Subject: CZ-19-0673-42 – Design Build Construction of Heating, Ventilation, and Air Conditioning (HVAC) at Multiple Sites – Package A (SDUSD Project # 90290071.1)

Notice to Proceed: No. 16– Fix Broken Lights at Bird Rock Elementary School

Project:	Bird Rock ES HVAC Phase 2	Document:	050
Title:	Building 03 Light Fixtures - Falling	Sub Ref. No.:	00
Contract No.:	CZ19-0673	Date:	05/06/2020
From:	Soltek Pacific	Required Date:	05/08/2020
To:	StudioWC	Response Date:	05/07/2020
Plan Ref:	N/A

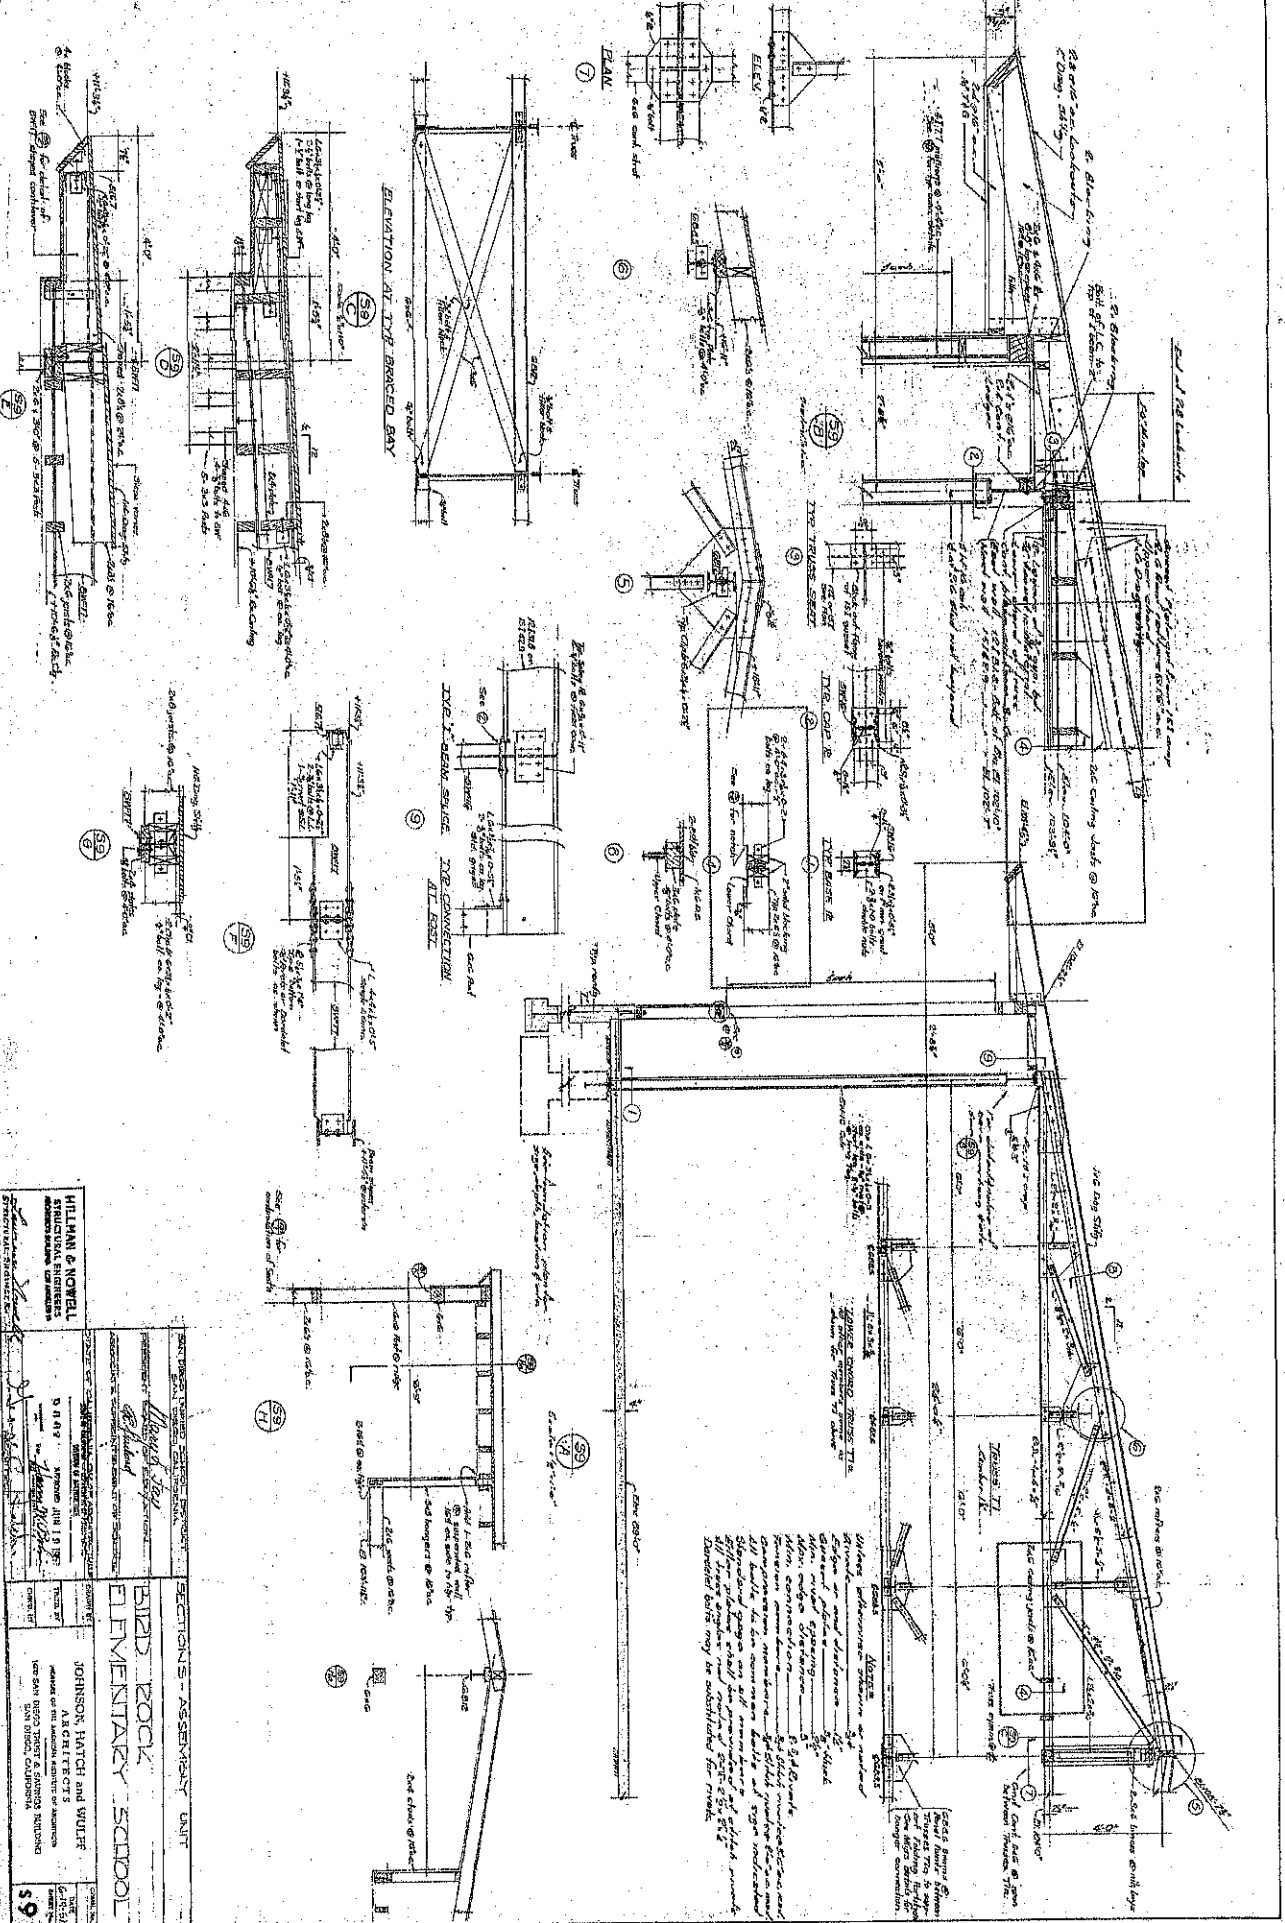
An existing line of light fixtures fell from the ceiling while the contractor was working in the adjacent area and on the roof. The lights were fastened to the drywall ceiling with toggle bolts and wood screws through ceiling tile glued to the drywall. See attached photos for reference.

What type of fasteners should be used and is it acceptable to fasten the lights to the ceiling joists for reinstallation of light fixtures that have fallen?
Please advise.

The Ceiling construction is 2x6@ 16"o.c. running between the Steel roof trusses. If needed you can add 2x6 blocking with an A35 each end for fastening the light fixtures. Use #10 WS for fastening the light fixtures to the 2x6 ceiling or blocking members. The WS should be long enough to get 2" of embedment into the wood framing and be located in the middle 1/3 of the member width.

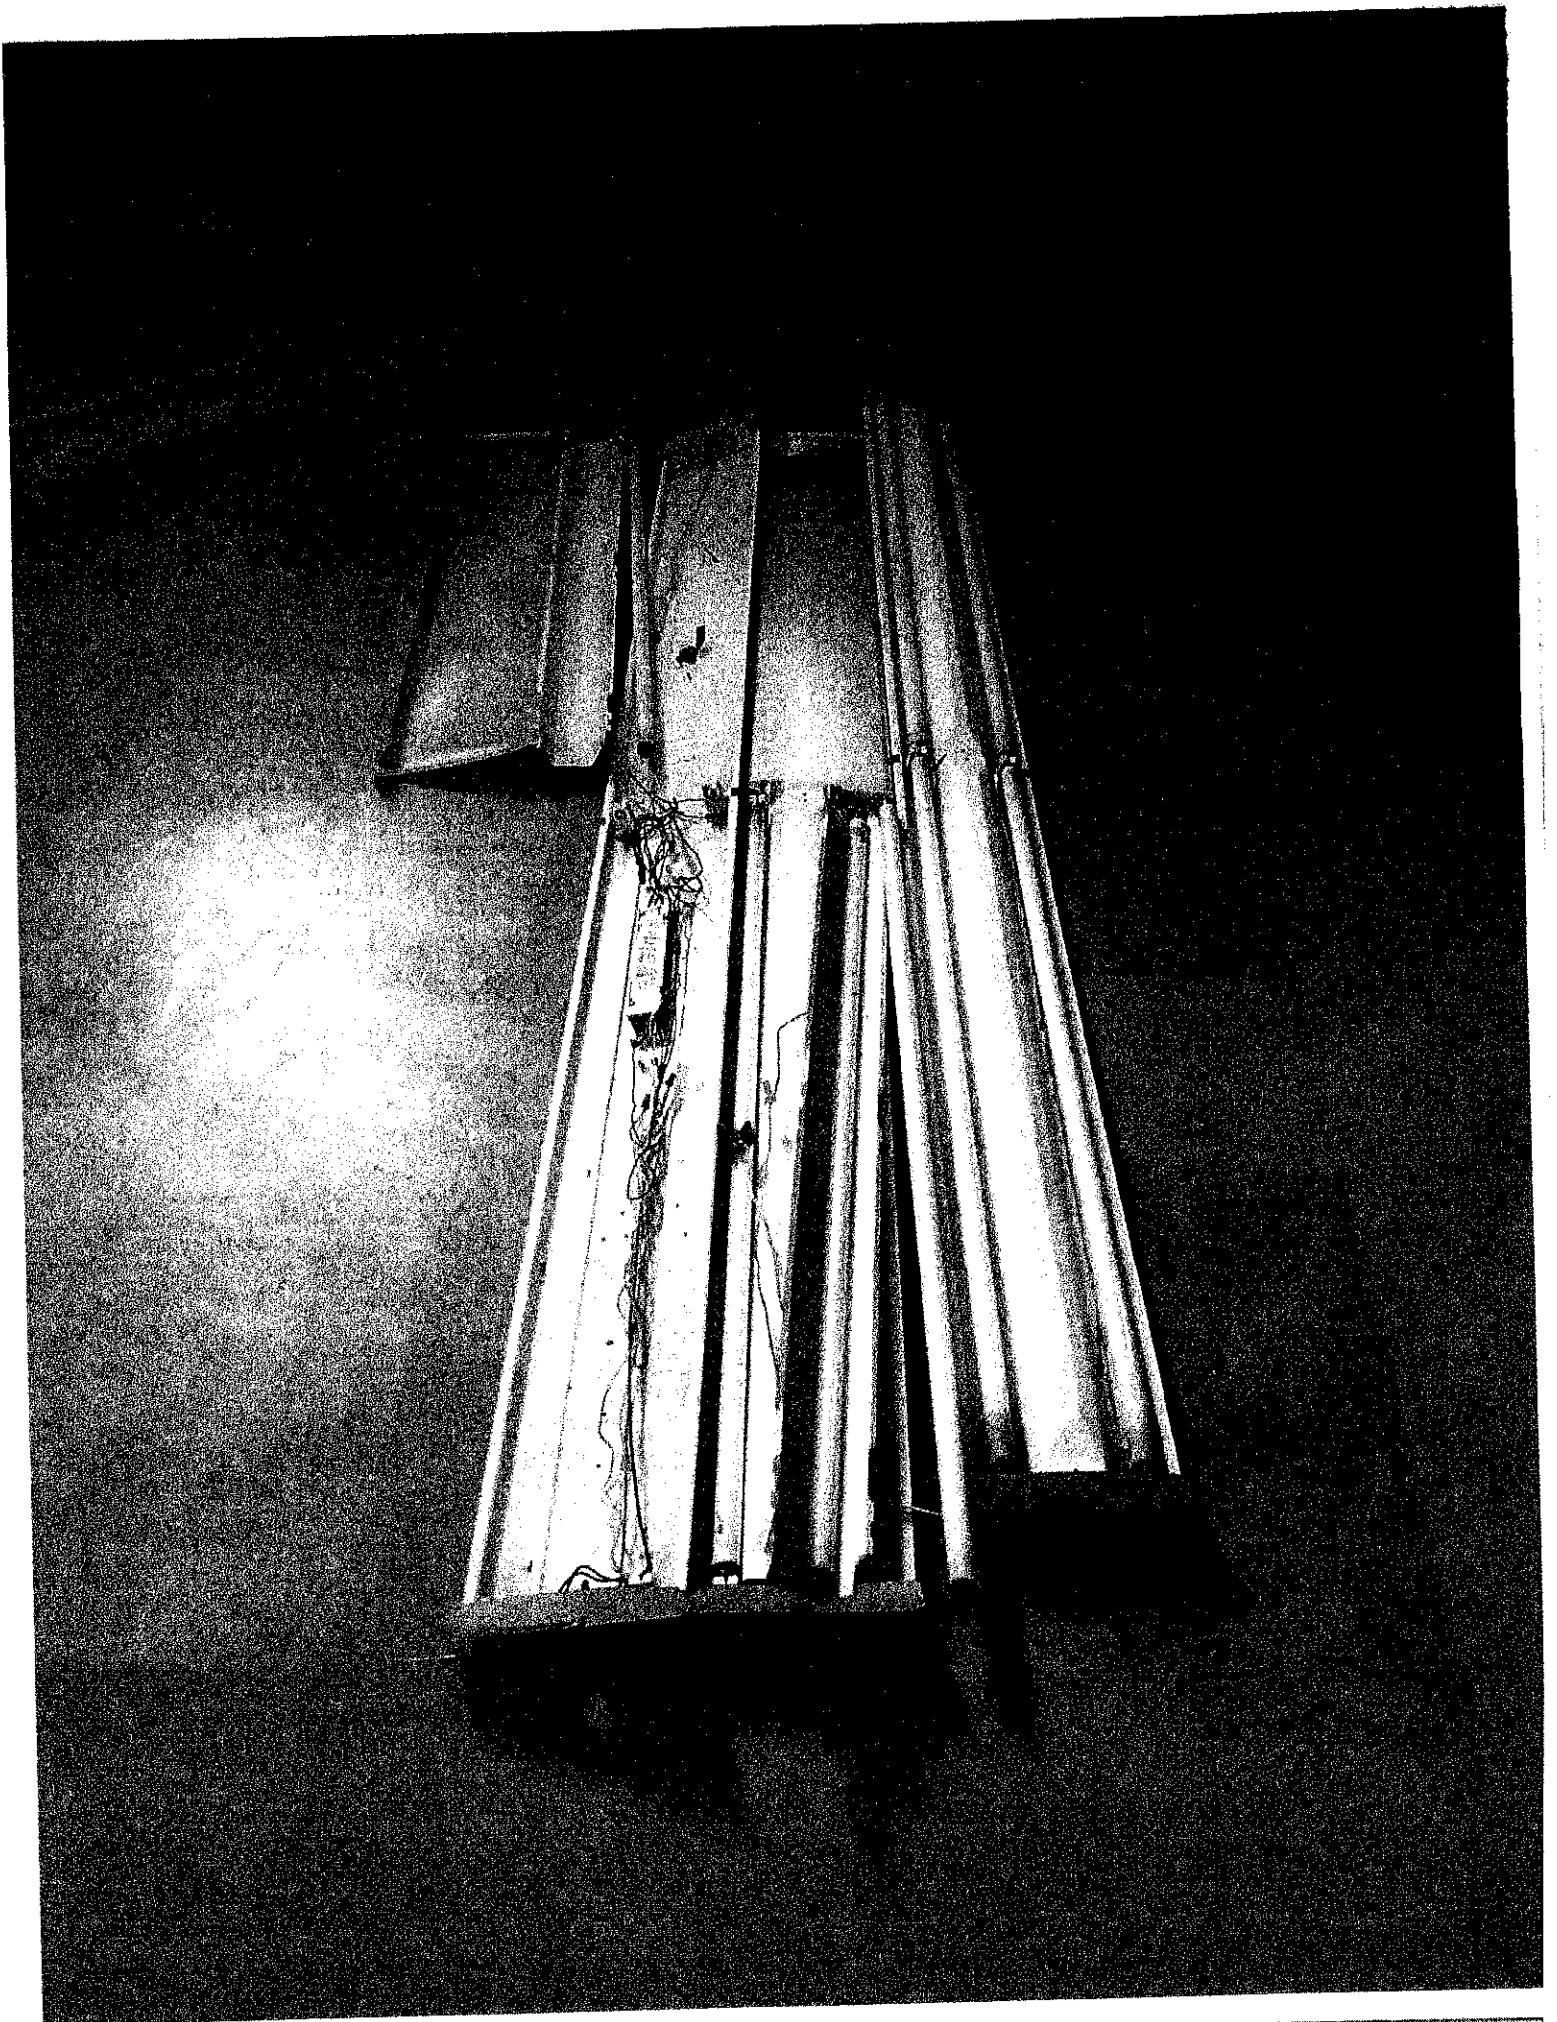
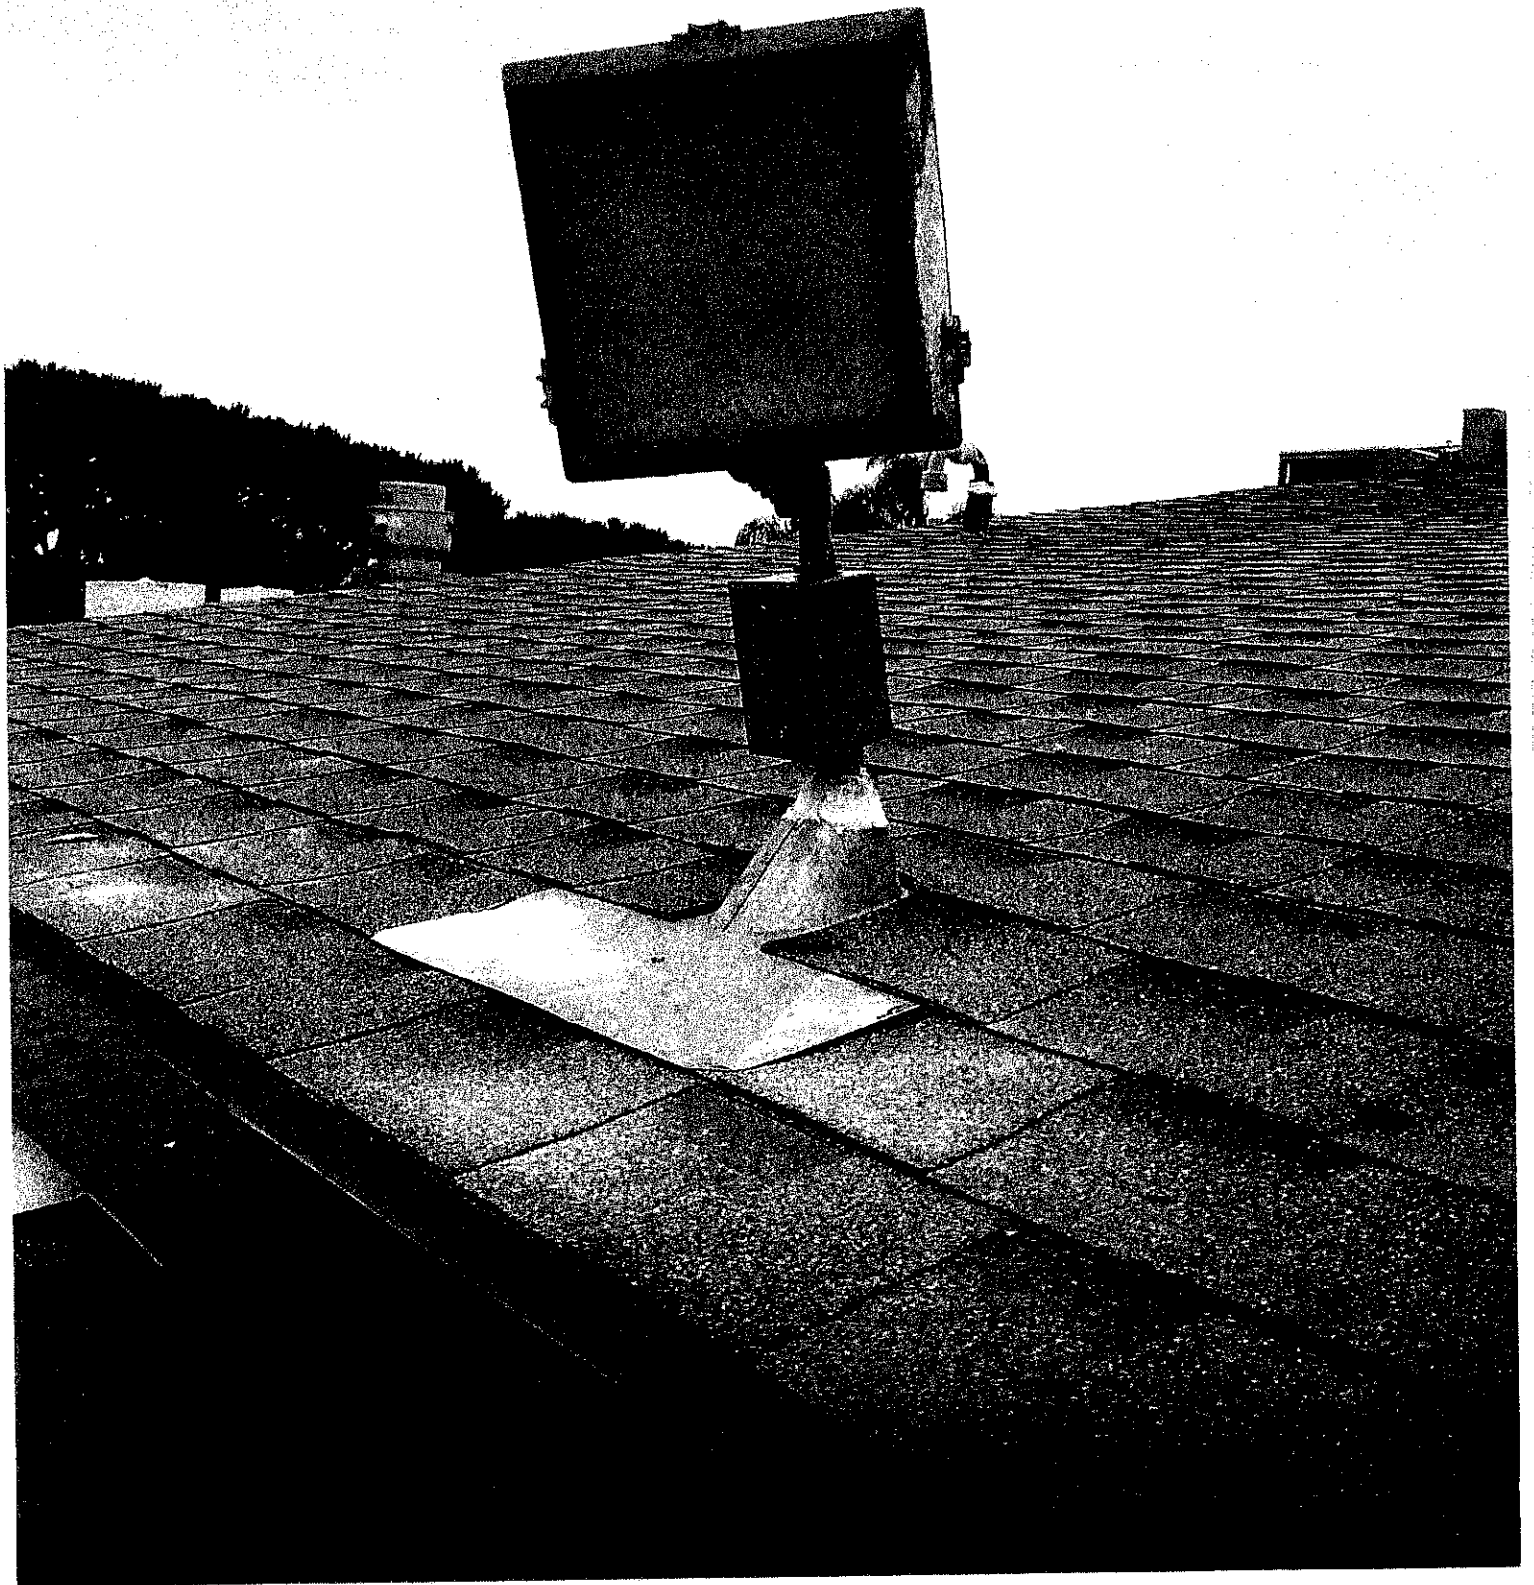
Question: An existing line of light fixtures fell from the ceiling while the contractor was working in the adjacent area and on the roof. The lights were fastened to the drywall ceiling with toggle bolts and wood screws through ceiling tile glued to the drywall. See attached photos for reference.

What type of fasteners should be used and is it acceptable to fasten the lights to the ceiling joists for reinstallation of light fixtures that have fallen?
Please advise.

Answer: The Ceiling construction is 2x6@ 16"o.c. running between the Steel roof trusses.
 If needed you can add
 2x6 blocking with an A35 each end for fastening the light fixtures. Use #10 WS for
 fastening the light fixtures to the 2x6 ceiling or blocking members. The WS should
 be long enough to get 2" of embedment into the wood framing and be located in
 the middle 1/3 of the member width.
 S. Welsh
